Subject: Submission on Proposed Material Alterations to the Draft Clondalkin Local Planning Framework (Variation No. 1).

Reference Material Alteration: MA 25 (Section 8.7 / Figure 8.32)

Appendix 1: Alternative cross section C-C through Millpark house No: 136 (graphics taken from SDCC Clondalkin LPF Ch8 Urban Design Strategy report page 26)

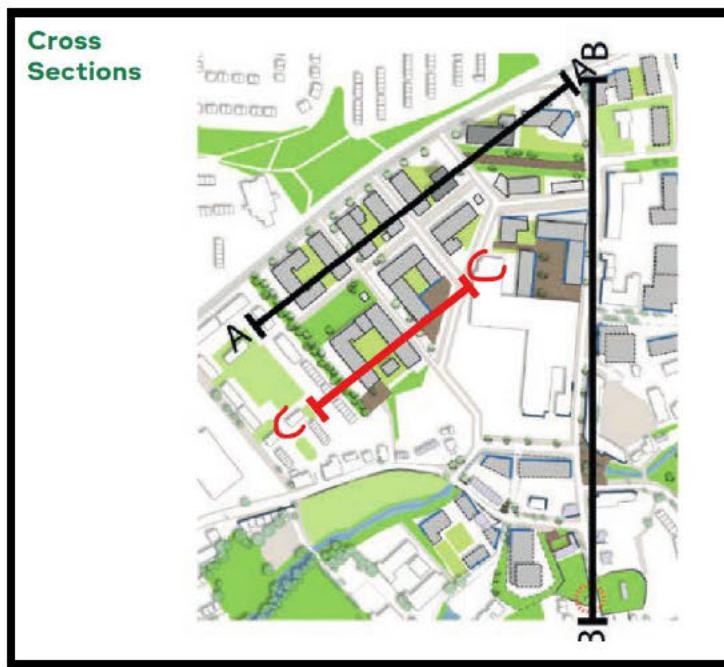
In addition to this the SDCC Clondalkin LPF Ch8 Urban Design Strategy report on page 26 does not take into consideration that all properties in Millpark are not the same height. Please refer to Figure 1 below and appendix 1 & 2. Along my proposed cross section C-C aligned with my property [REDACTED] which identifies that the two story Millpark houses (No. 129 – 144) will be overshadowed by the proposed 9th Lock development which was not considered or overlooked by the planning team.

I would also like the Council to investigate the assumption that all Millpark residential structures along the proposed development boundary line are five stories in height, this is a significant planning oversight.

Appendix 2: Cross section at point C-C highlighting the height difference between the Millpark Apartment blocks, the proposed new develop height and the Millpark houses (in Red) No. 129 – 144 for consideration.
